Certificate of Appropriateness Case Report

Filing Date: June 8, 2016
Case No.: **2016-016257COA**
Project Address: **200 LARKIN STREET**
Historic Landmark: Civic Center Landmark District
Zoning: P (Public) District
80-X Height and Bulk District
Block/Lot: 0353 / 001
Applicant: Carolyn Kiernat
Page & Turnbull
417 Montgomery Street
San Francisco, CA 94104
Staff Contact: Eiliesh Tuffy - (415) 575-9191
eiliesh.tuffy@sfgov.org
Reviewed By: Tim Frye - (415) 575-6822
tim.frye@sfgov.org

RESPONSE TO COMMENTS FROM ARCHITECTURAL REVIEW COMMITTEE HEARING

McAllister Street Elevation

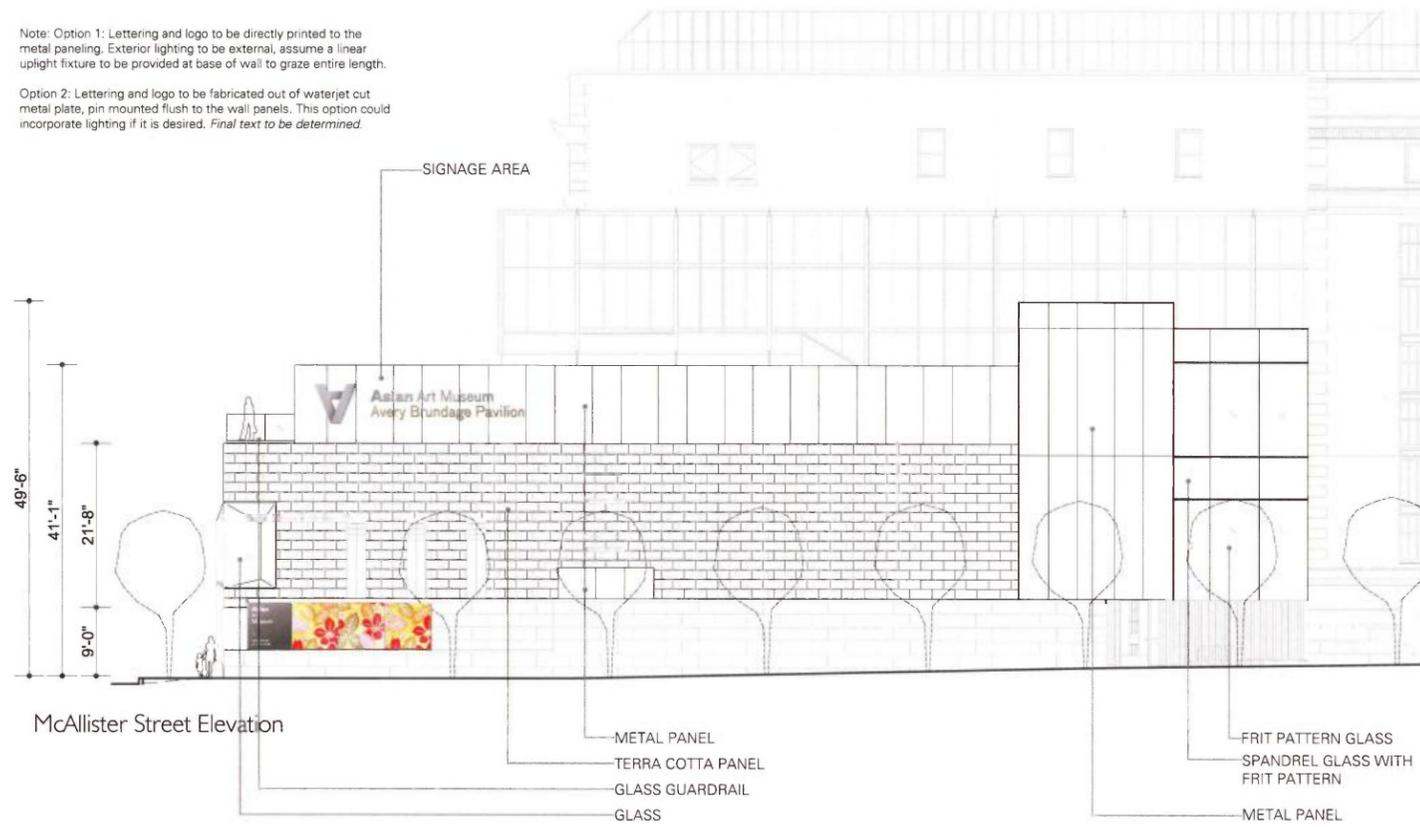
The signage as proposed in the June 23, 2017 plans (Page 49) appears non-conforming with certain controls of the Special Sign District. The project's signage program is subject to further review by department staff to ensure conformance with the Planning Code and Sign Design Guidelines for historic resources, as stated in the proposed conditions of approval in the Planning Department Recommendations section of this report.

Response: Signage has been incorporated at the portion of the granite wall located at the Hyde and McAllister streets.

Glazing detail in section - at faceted panel

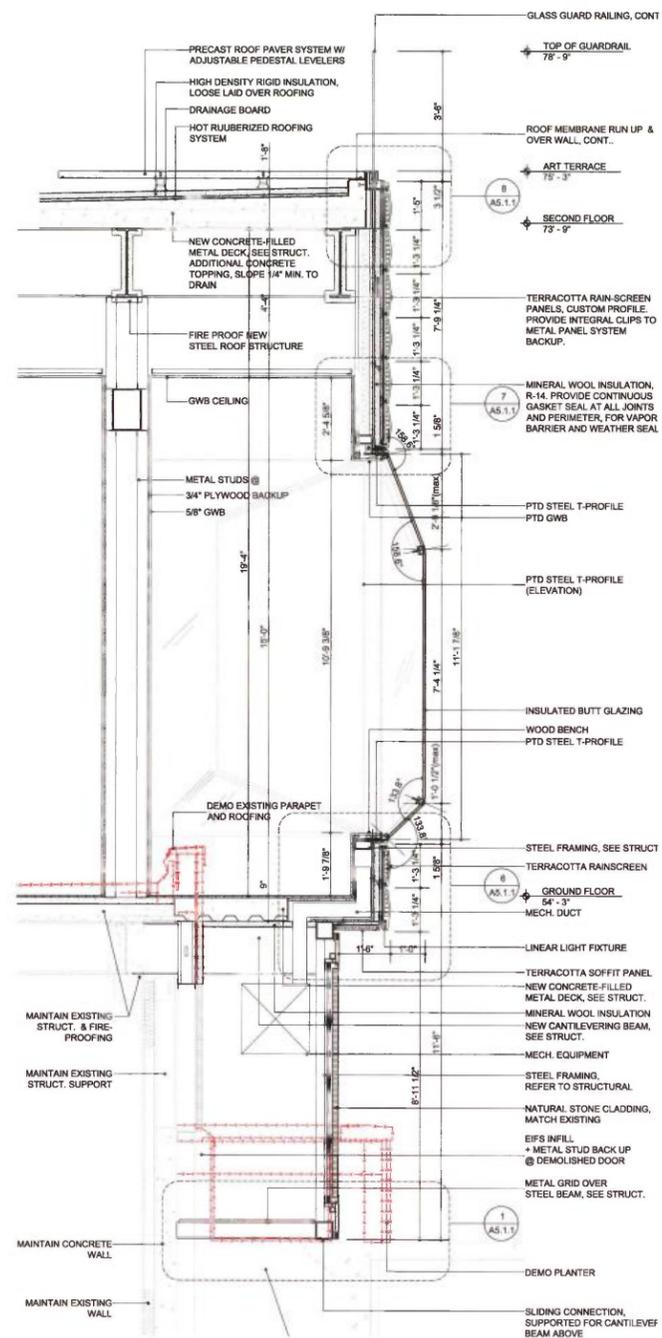
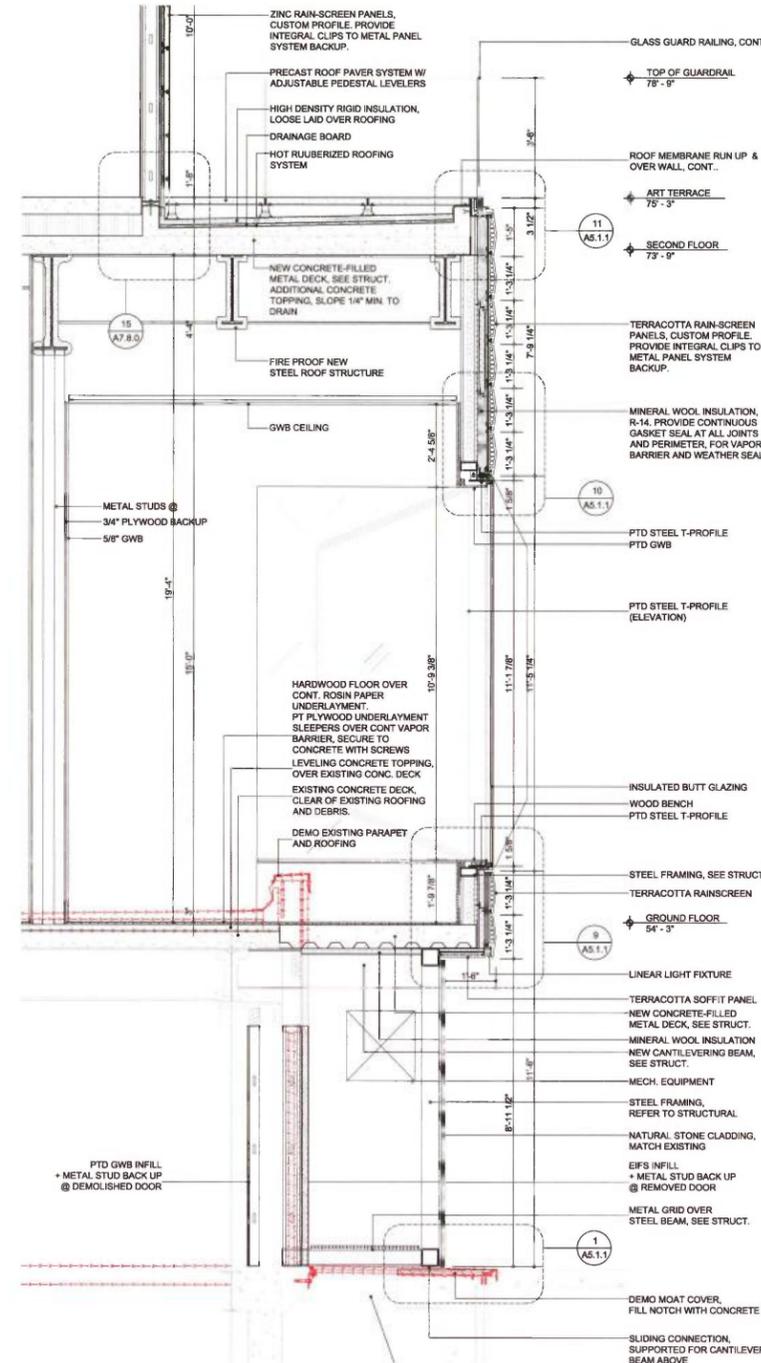
- Construction detail drawings for the faceted glass window are provided in the sponsor packet (Pages 38 & 39). A mock-up has also been recommended by staff as a condition of approval.

Glazed window: The proposed project includes a faceted glass window along Hyde Street. This element was viewed as a positive change to the project by the ARC. The ARC commented on the architectural interest that the window brings to the addition and the potential that it has to activate Hyde Street. However, the committee requested that the project team provide details that demonstrate the constructability of the design. One of the ARC members also requested that the project team study a frit on the flat panels.

Response: This graphic appendix includes the development of details for the faceted glass window. The renderings have also been updated to show a more realistic image of window when constructed. See pages 38 – 39 for details and reference images for the faceted glass design. The project team prefers clear glass throughout the faceted window to keep the design simple and maximize views into and out of the museum.

Design alternate with minimum mechanical enclosure area and dead space created to maintain maximum occupiable floor area

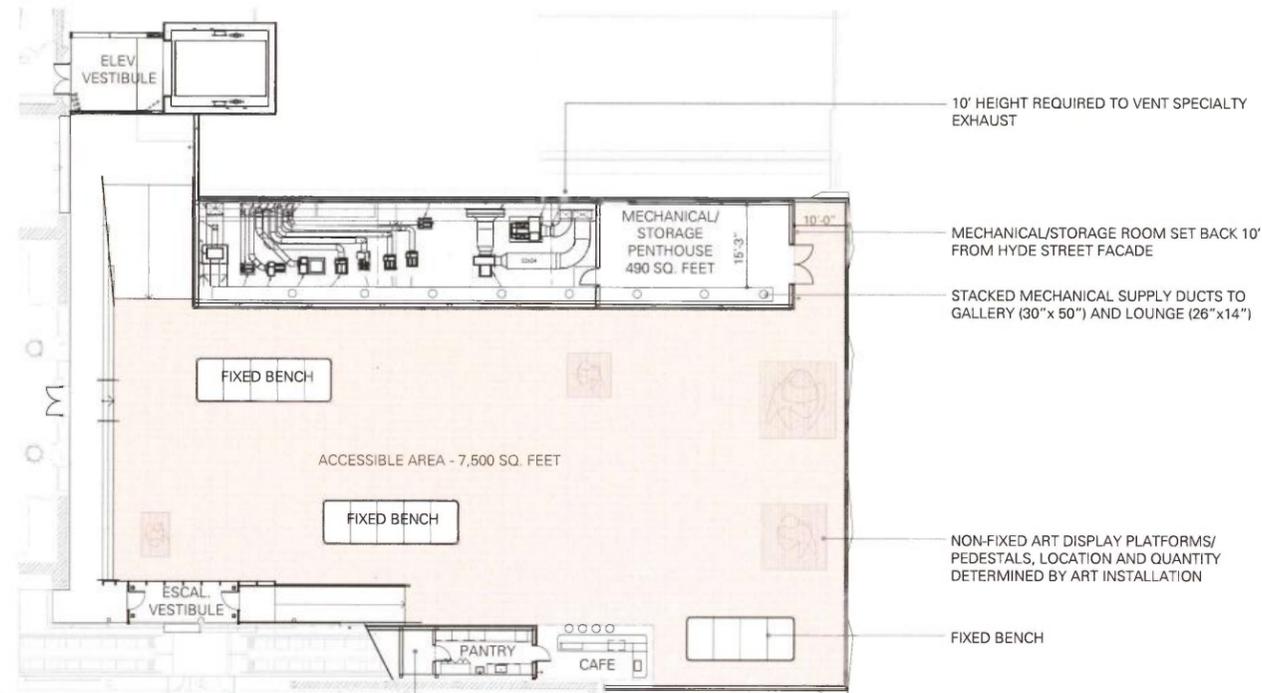
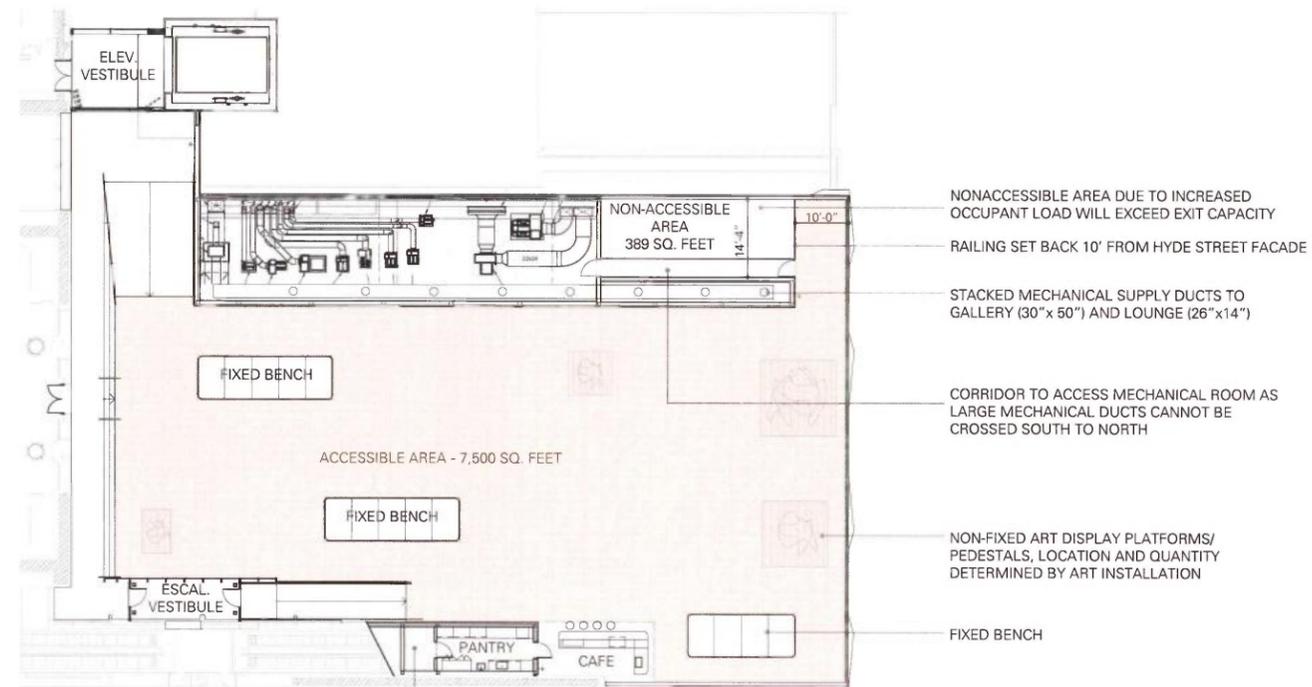
The alternate design on Page 41, which proposes a minimum mechanical enclosure at the northeast corner of the roof terrace, creates a horizontal datum in greater conformance with the horizontal compositional elements of both the subject property and buildings in the district. This area could be further refined to remove the barrier railing and allow for additional circulation and possibly sculptural installation at the northeast corner. While safety and aesthetics adjacent to the museum's utilitarian loading area may be of concern, a code-compliant railing wrapping the corner would allow for greater activity and visual interest to this area of the roof terrace as viewed from the public right-of-way.

Response: The proposed addition is scaled to align with the existing rusticated base of the historic building which serves as a datum line that provides continuity from the historic building to the proposed addition. The massing of the mechanical rooftop equipment has been reduced as much as possible. Sections of the area are provided in this package to illustrate this point. See pages 40 – 41.

Enlarged elevation showing art wall with proposed clips

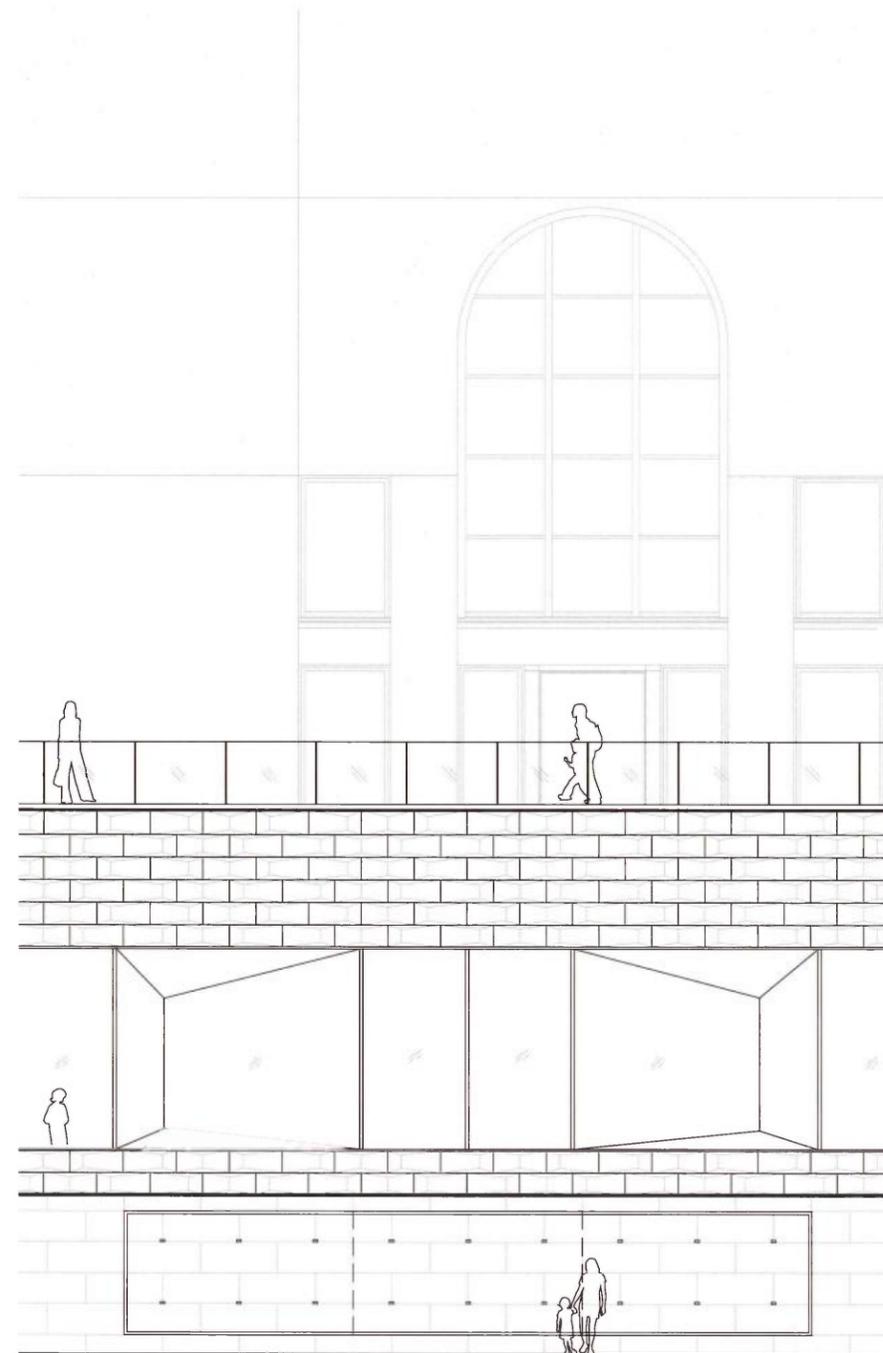
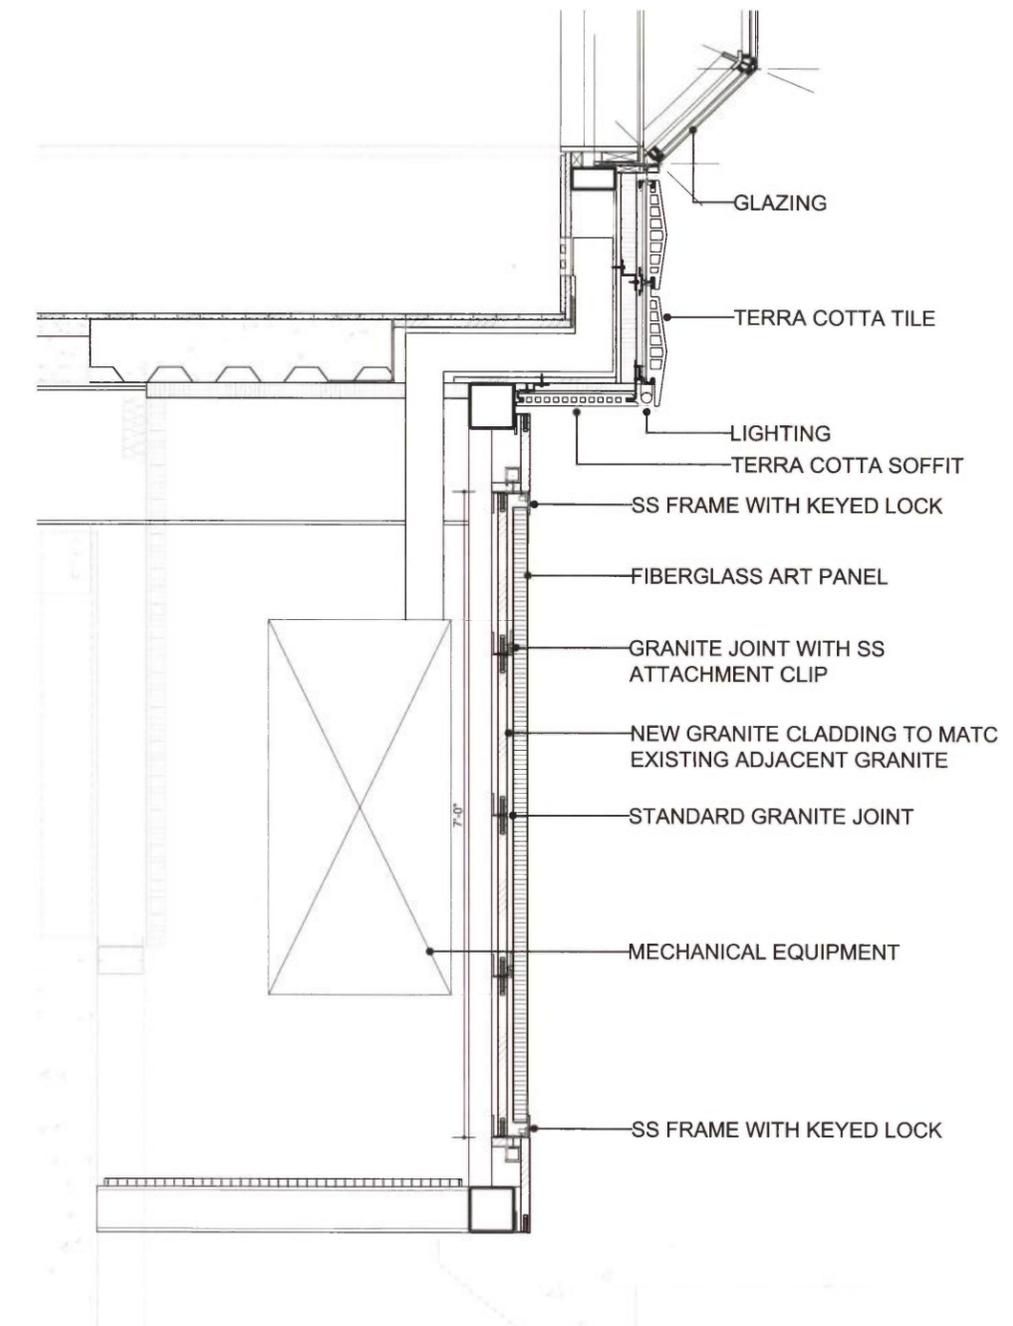
HYDE STREET COMMUNITY MURAL WALL – VISION AND SPECIFICS

Response: The art wall will be detailed so that it has a perimeter frame. The granite wall behind the art wall will have clips that can support a fiberglass art panel. The art panel containing the artwork will be changed periodically. See page 47.
